**ATCO Gas Australia Proposed
Access Arrangement for the Mid-West and
South-West Gas Distribution Systems**

**Review of Technical Aspects of
the Proposed Access Arrangement**

**Report to
Economic Regulation Authority of
Western Australia**

**from
Energy Market Consulting associates**

Figure 5: ATCO's investment governance hierarchy

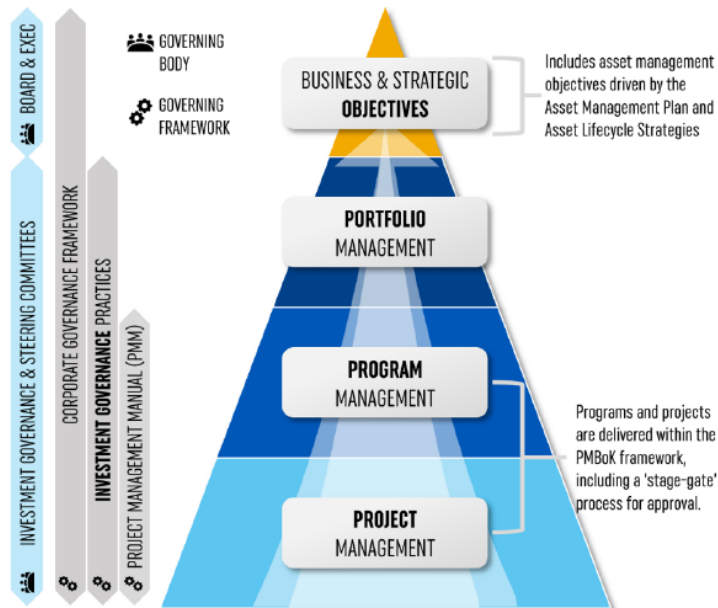
61. The figure below shows ATCO's investment governance hierarchy, the key features of which are:
- business and strategic objectives set the overall direction for the business;
 - portfolio development and execution oversight by executive, Board and other committees⁴; and
 - a suite of investment policies, frameworks, practices, and procedures⁵.
62. We consider that ATCO's investment governance hierarchy is consistent with good industry practice.

Figure 6: ATCO's annual planning process

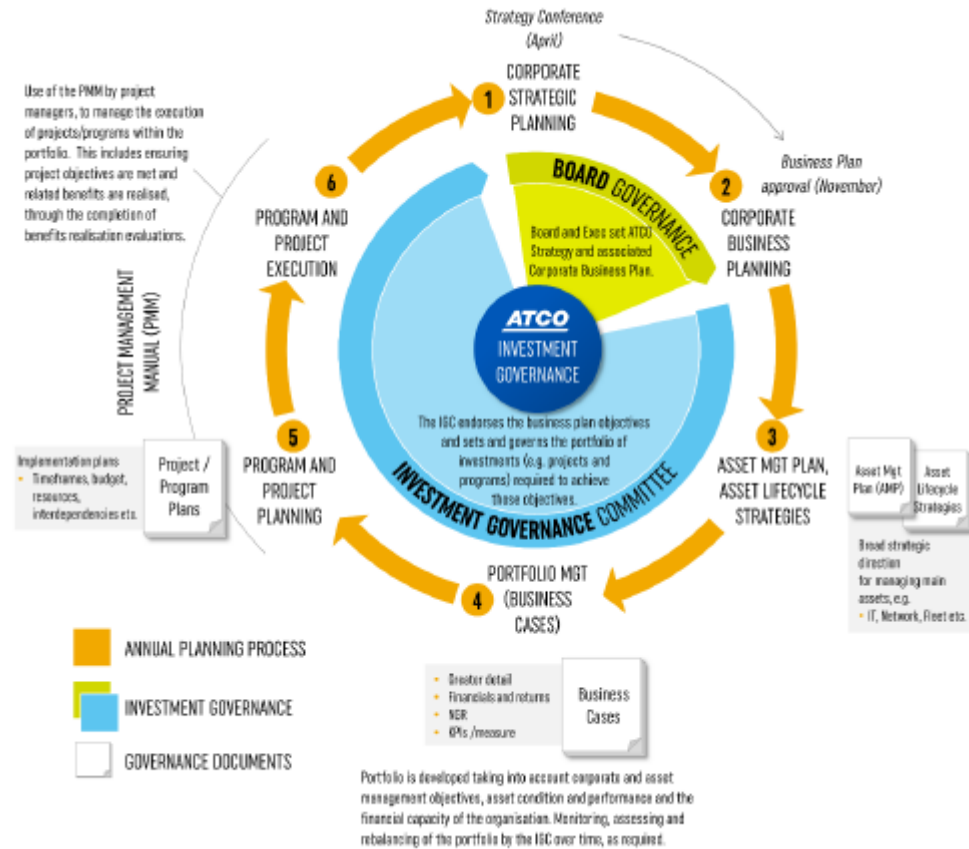
63. ATCO has developed the AA5 proposal capex and opex forecast by applying its annual planning process, as shown in Figure 6. ATCO identifies and sets strategic and business objectives, sets performance measures and targets, and identifies projects and programs of work (opex and capex, network and non-network) to deliver on the objectives and targets.
64. We consider that this planning process is consistent with good industry practice.

70. In Step 4 of Figure 6, ATCO manages 'portfolio construction', portfolio prioritisation, and applies portfolio 'governance', where the portfolio is comprised of the programs and projects identified in the Business Plan. The Investment Governance Committee (IGC) provides overall portfolio management governance.

Figure 8: Time trend of ATCO’s actual and forecast B3 connections

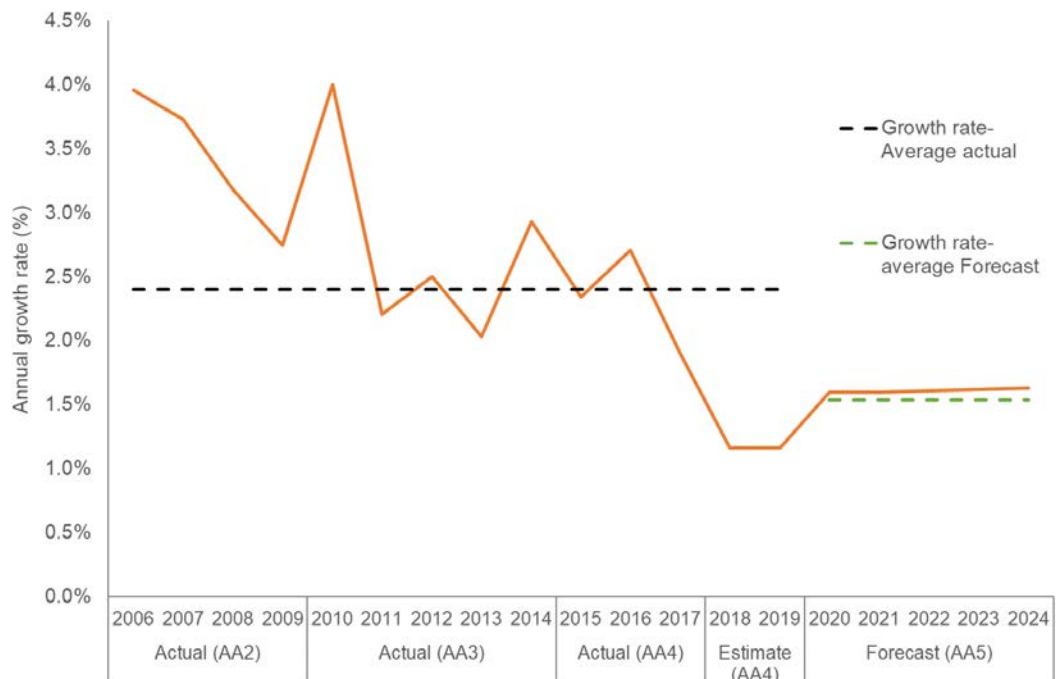
- 103. As the table above shows, ATCO estimates that new connections in 2018 and 2019 will be considerably less than in 2017. This comprises significant decreases for B1, B2 and B3 customers, and net disconnections of A1 and A2 customers. ATCO also forecasts a significant decline in average volumes across its B1, B2 and B3 customer classes in 2018 and 2019, with further decline in AA5.
- 104. ATCO forecasts that new customer connections will revive in AA5, starting in 2020, led by a significant increase in B3 connections. Its longer-term trend shows a steep decline in customer growth rates since 2006, as shown in the following figure.

Figure 10: Percentage changes in All Industries wage price indices (corresponding quarter of previous year)

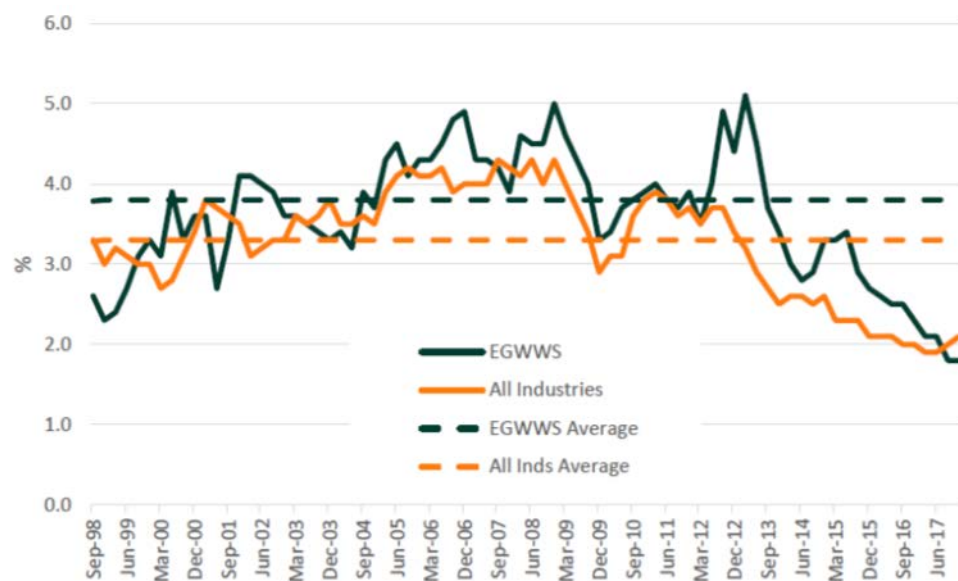
142. ATCO has relied on a report by Synergies Economic Consulting (Synergies) to support its proposed real labour cost escalation assumption²⁸. In the report, Synergies states that wages have grown faster in the EGWWS²⁹ sector than for the 'all industries' average. However, Synergies observes that the mining boom has eased considerably over the last few years and since then the wages growth for EGWWS has slowed such that it is now broadly in line with wages growth in other sectors, as shown in the figure below. The figure also shows nominal wage growth currently at around CPI, meaning there is currently no real wage growth.

144. While Synergies has calculated a 20-year average premium of 0.5% for EGWWS over all industries, it can be seen from the figure above that there was little if any aggregate premium over the first 10 years. The premium that Synergies has calculated has largely arisen from the lag in EGWWS sector wages falling in the second decade of the data, relative to wages in 'all industries'. We consider this to be only a weak indicator that such a premium will develop again and persist over AA5.

Figure 13: AA4 network sustain capex variance analysis against ERA allowance – by cause

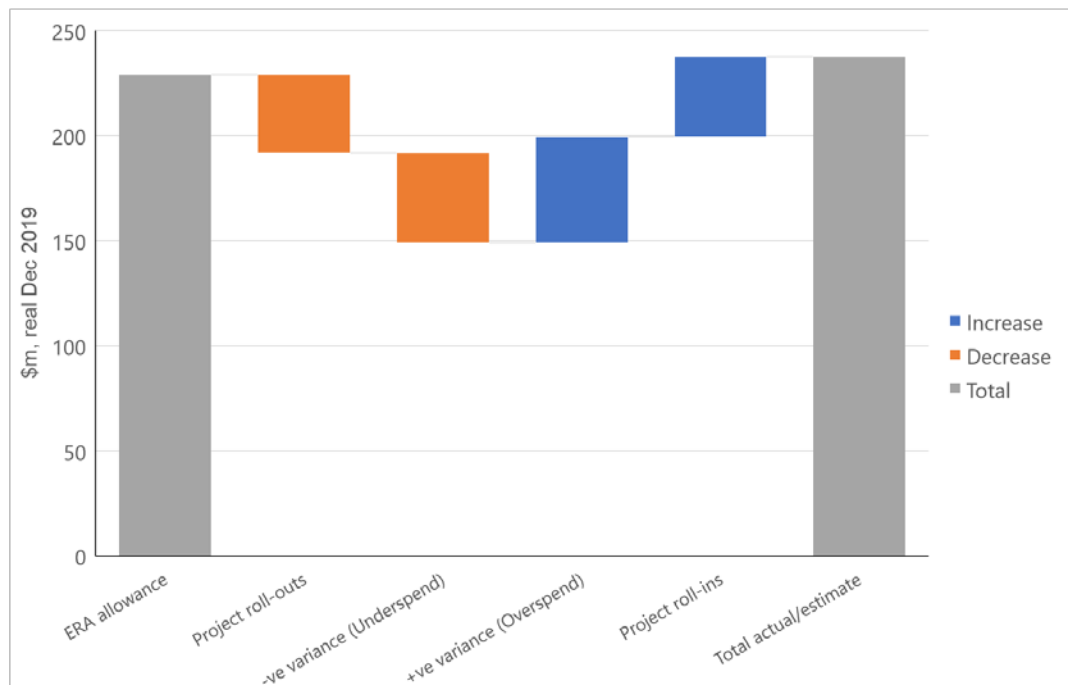
184. There is a large movement of capex projects in and out of the network sustaining capex portfolio, and yet ATCO forecasts to manage to within less than 5% of the ERA allowance, as shown in the figure below. Notwithstanding that there may not be a significant expenditure variance at the aggregate level, we have nevertheless examined the areas of additional spend for evidence as to whether ATCO may have sought to 'target the allowance' as opposed to incurring only expenditure that was suitably justified by reference to its expenditure governance framework.

Figure 15: AA4 network growth capex variance analysis – by capex driver

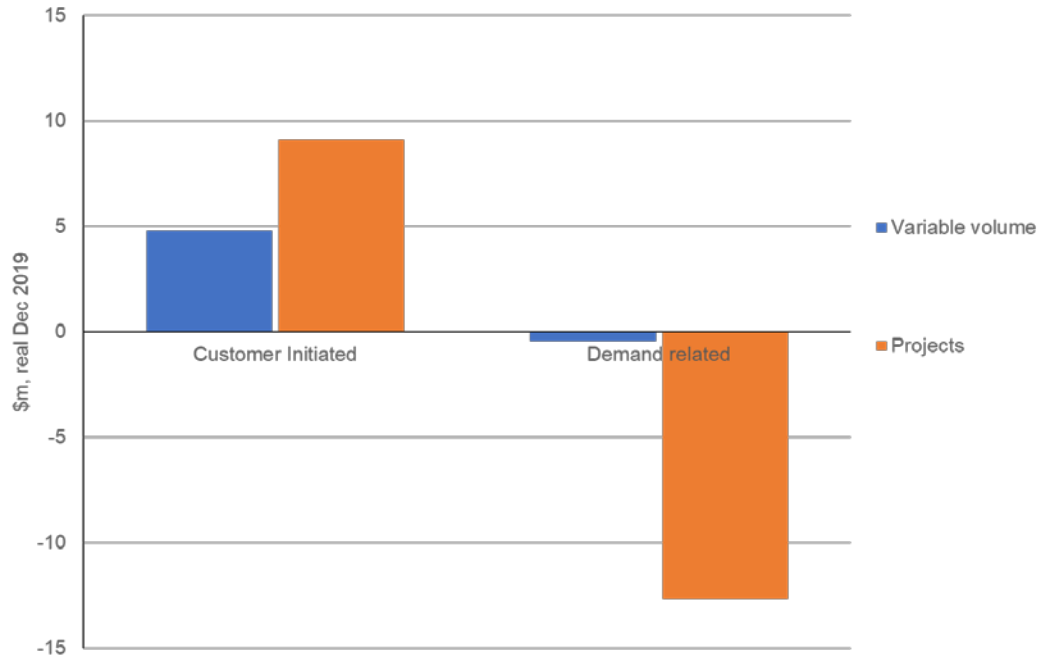
252. We observe a large shift in expenditure from demand related projects to customer-initiated projects, as illustrated in the figure below. We understand this was largely in response to the drop in demand, as reflected in ATCO's modelling, and higher than forecast customer connections. Both factors are largely outside ATCO's management control.

Figure 16: AA4 network growth capex variance analysis – by cause

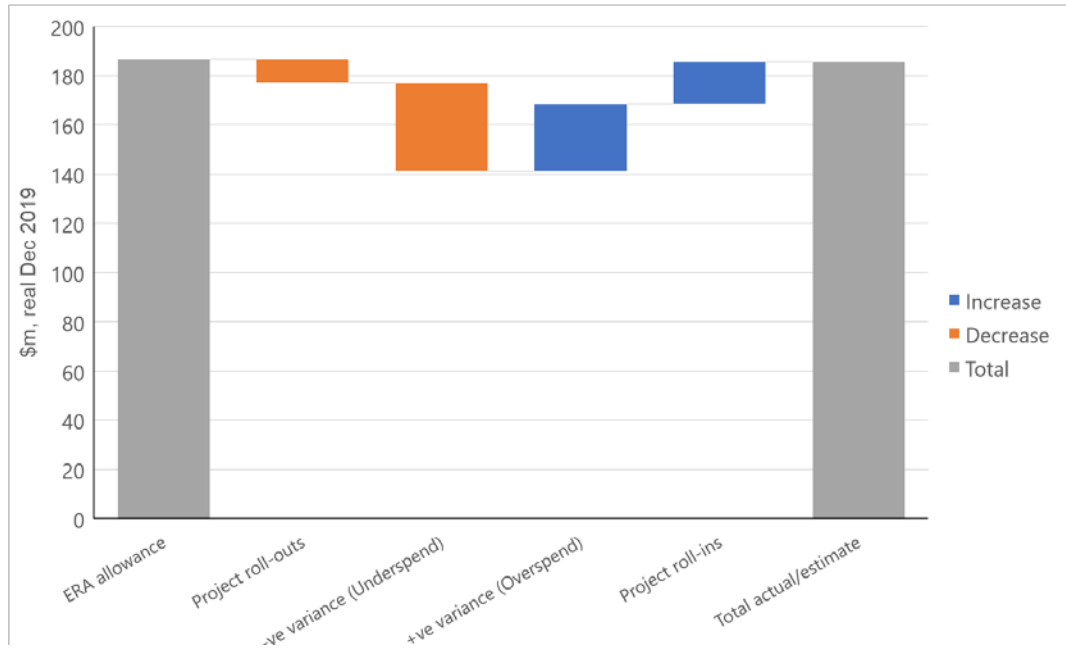
253. ATCO’s actual and forecast expenditure for AA4 would result in it managing to within less than 1% of the ERA allowance, as shown in the figure below. As with network sustaining capex, we have examined justification for the variance in the components of expenditure, notwithstanding the small aggregate variance.

Figure 17: AA4 structures and equipment capex variance analysis – by cause

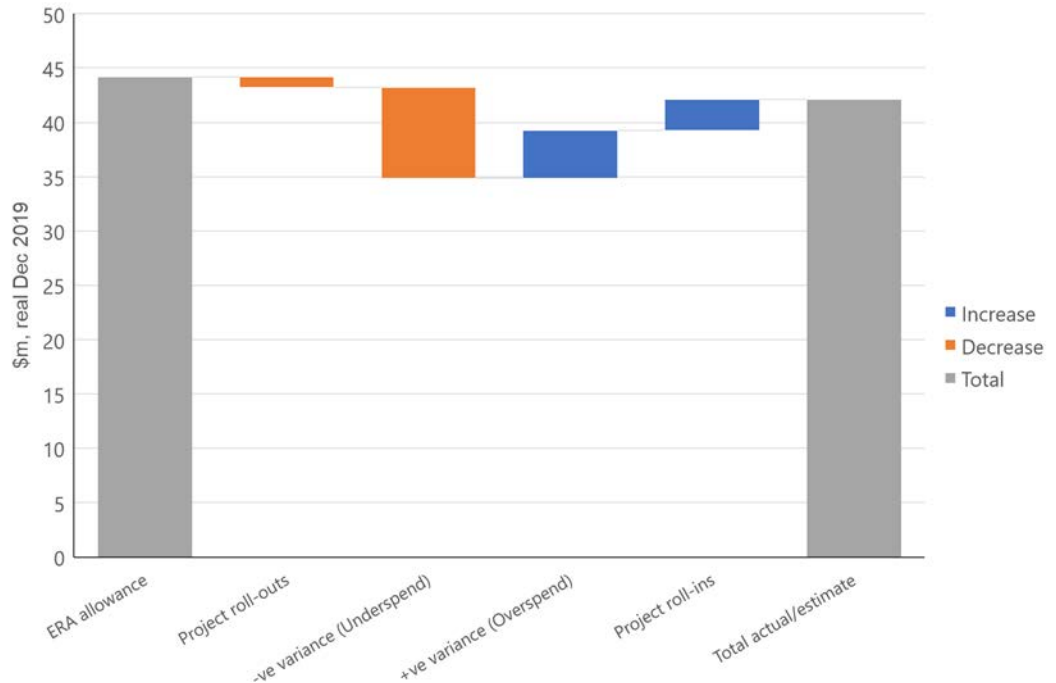
277. As shown in the figure below, there was a relatively large movement in capex projects in and out of the structures and equipment capex portfolio, but ATCO expects its aggregate expenditure to be within 5% of the ERA allowance. We have examined justification for the variance in the components of expenditure, notwithstanding the small aggregate variance.

Figure 22: Forecast AA5 CIC metersets volume and capex

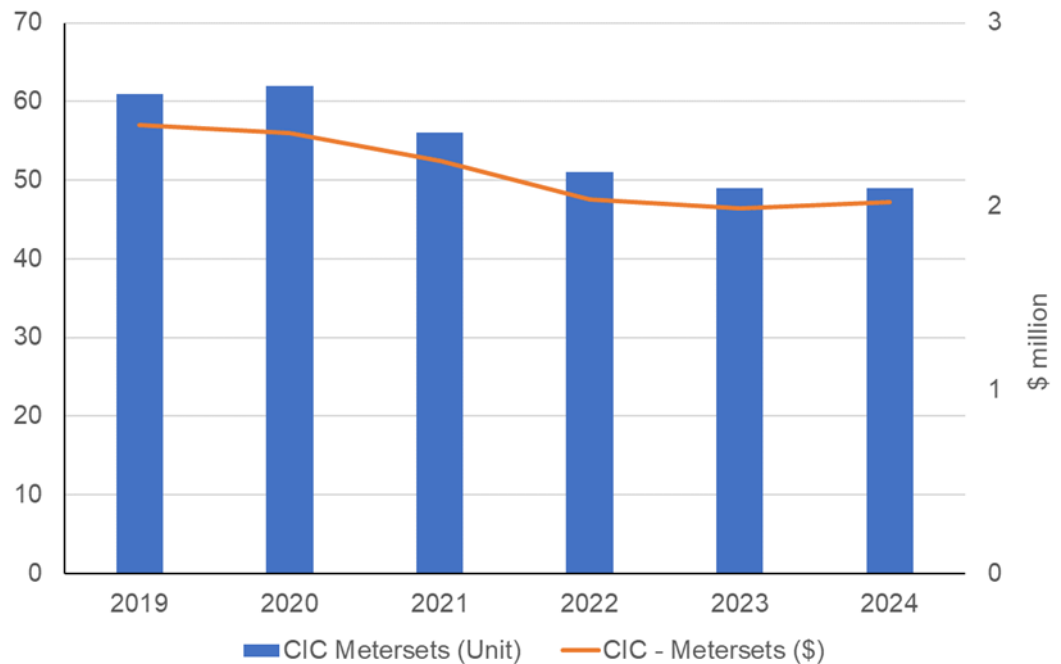
429. On the basis of the information provided, we consider the proposed expenditure on CIC metersets is likely to satisfy the capex criteria.
430. AL18 new meter connections are customer-initiated standard installations and form part of the variable volume activities. ATCO proposes connecting a steady 22 new AL18 meters per year in the AA5 period at a total cost of \$0.7m. Given our concerns regarding ATCO's growth outlook and ATCO's own forecast decline in third party demand for CIC metersets (per Figure 22), we consider only half this amount is likely to satisfy the capex criteria.

Figure 32: AA4 growth NPV analysis – ATCO base case as presented

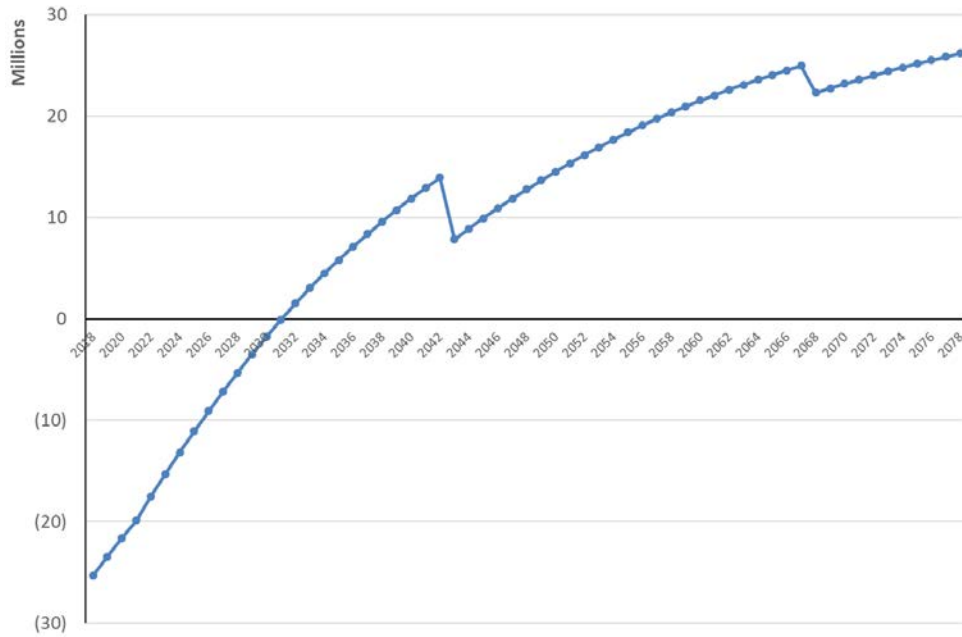
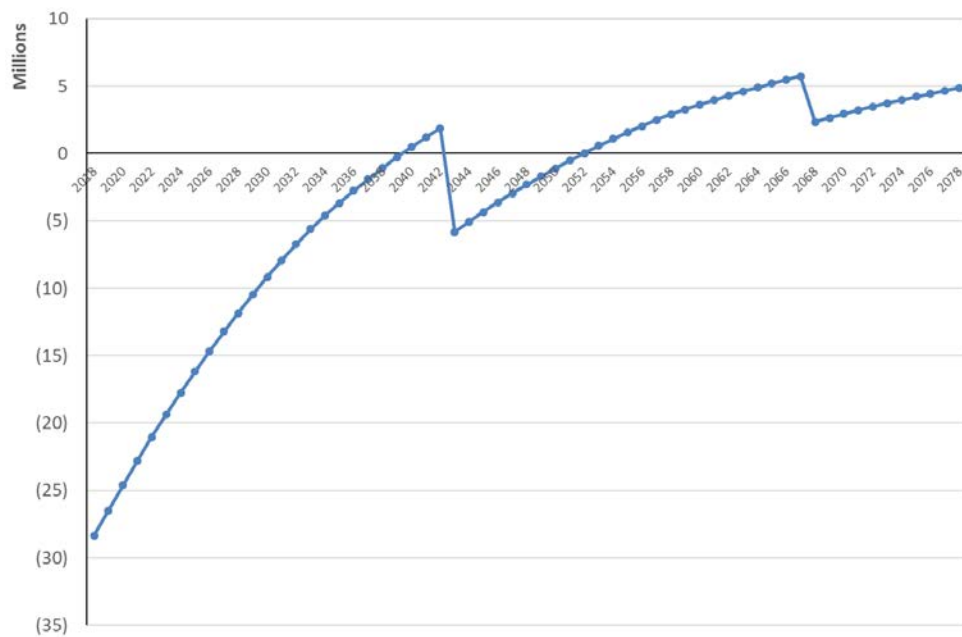
586. To better understand how the NPV builds over time, we established an annual PV calculation in ATCO's model, and accumulate this over time. The final year accumulated PV is the same as the NPV that ATCO presents. These graphs are able to show when the NPV turns positive, and to capture the effects of the replacement cycles. We present first our illustration of PV build-up, from the model as presented by ATCO in the figure below.

587. In the figure below, we present our analysis in which we have tested the strength of ATCO’s conclusions by changing assumptions as indicated above.

Figure 34: AA5 Greenfields growth NPV analysis – ATCO base case as presented

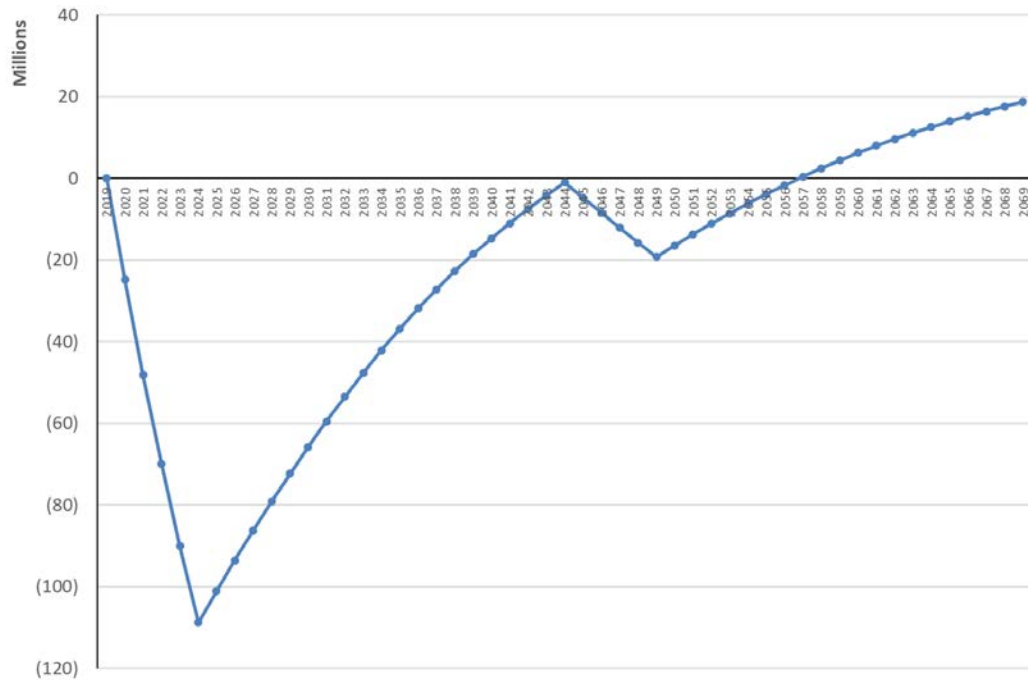
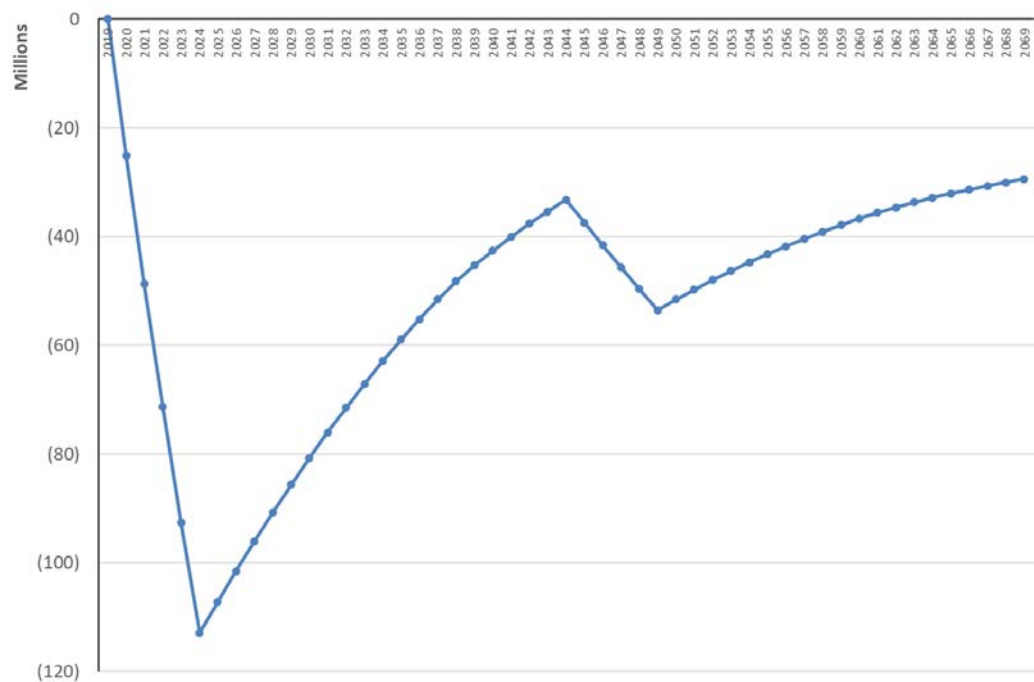
- 603. For reasons that we described in our 2014 report to the ERA, we consider it is not valid (and implicitly circular) in an incremental revenue test to assume tariff increases that do not yet apply. Rule 79(4) requires that ‘prevailing’ tariffs are used and we consider that a reasonable interpretation of this is that they should be tariffs that apply prior to adopting any changes to such tariffs that are the subject of the current regulatory determination.
- 604. We tested the sensitivity of ATCO’s AA5 model to maintaining the 2019 tariff assumptions in its modelling, rather than assuming the increase that it has sought from ERA starting in 2020. The result is shown below and, under this test the NPV is negative even with a 50-year analysis period. At the first ‘replacement’ refresh at 25 years, the NPV is negative \$32m, and after 50 years it is still negative \$29m.
